Proposal 15702
Ames DOT Warehouse Dock Expansion
Questions and Responses Set 3

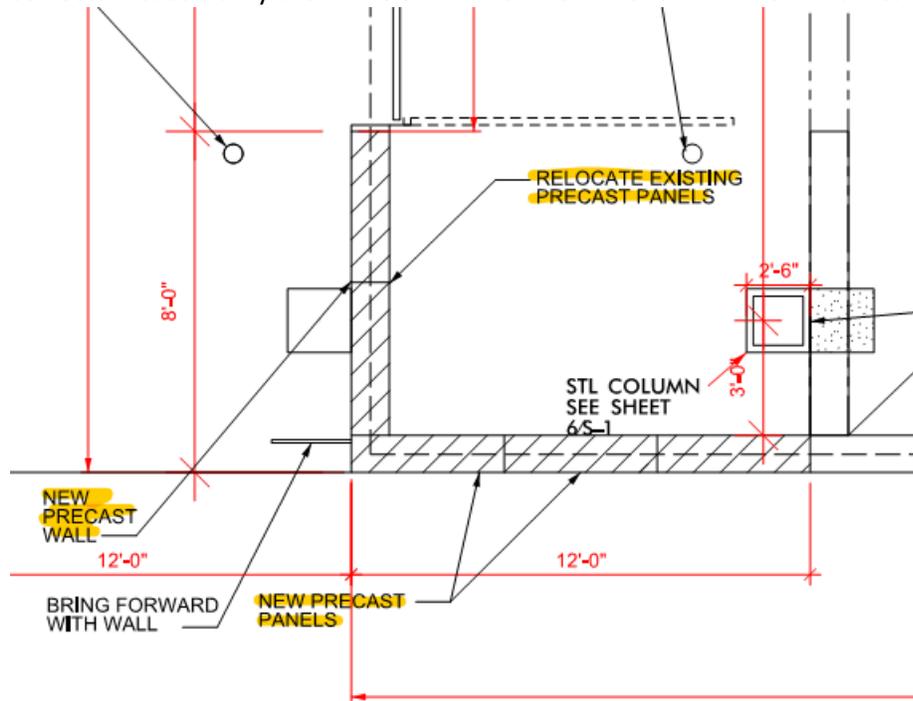
Q1) I have a question on drawing A-2R. Please see the screen shot at the bottom. At south east corner of drawing A-2R, different terminologies were used for "Precast Panels". I believe all the precast panels for the south expansion should be new, and the old south wall will remain, correct? Please clarify the "RELOCATE EXISTING PRECAST PANELS". Thanks!

R1 All wall panels are to be new panels on the south side addition. Ignore the note indicating "relocate existing precast panels". This note was supposed to be turned off on the drawings.
